Application Number: 10/701,146  
Filing Date: November 04, 2003  
Appellant(s): SMITH, FRANK C.

**EXAMINER'S ANSWER**

This is in response to the appeal brief filed 12/4/09 appealing from the Office action mailed 7/13/2009.

Figure 1.

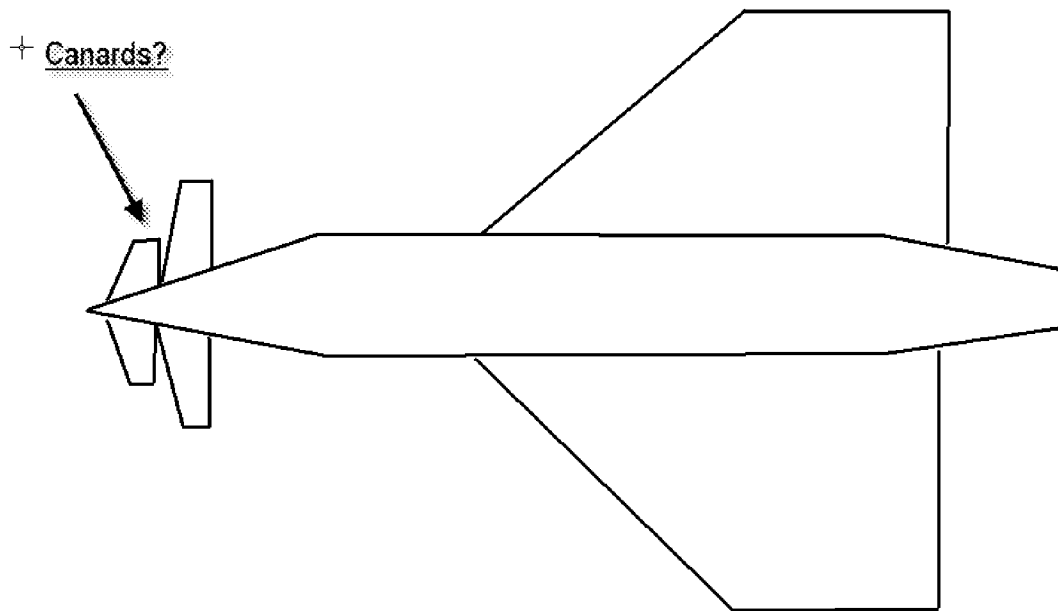
In addition, could it be that applicant is claiming that the canards are only two surfaces that are at the front of the aircraft? See the figure 1 below. Or is applicant claiming that the canard as being in the accepted view that a canard is show in figure 2 below.

The language of the claims lead to such confusion.

Figure 2.

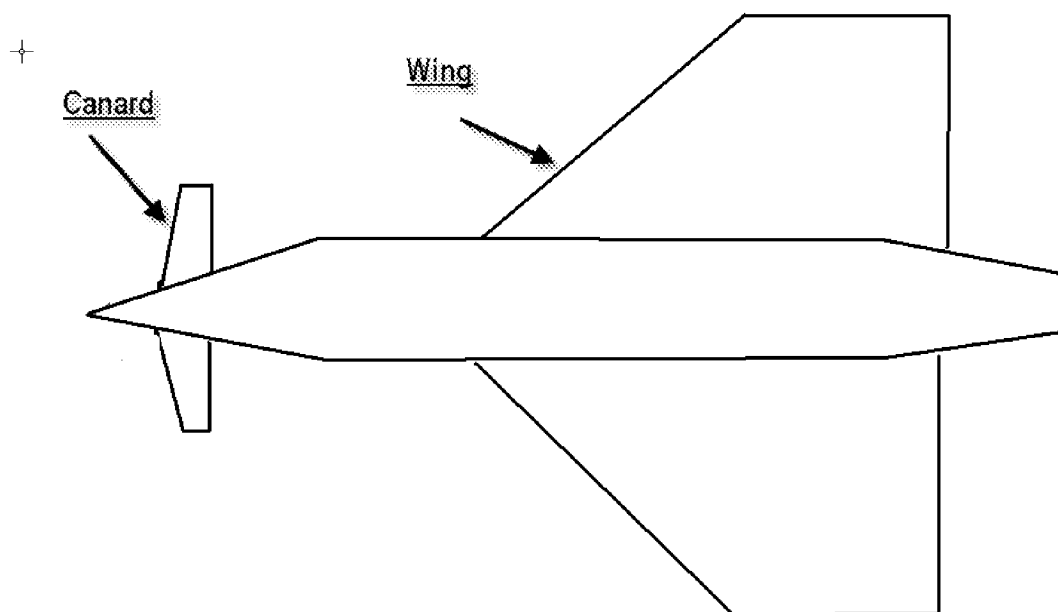
In response to applicant's arguments concerning the 35 USC 112 rejection, the examiner maintains that claims 1 and 11 are misleading and vague. As the examiner has stated in the rejection, a canard is "one of two small lifting surfaces in front of the main lift wings". The canard can not include the main lifting surface or the main wing. However, the applicant seems to have claimed that the canard must include the main lifting surfaces as well as the smaller lifting surfaces. Plus, as it is currently claimed, it is not understood if the applicant is merely claiming the smaller lifting surfaces only or the smaller lifting surfaces along with main wing.
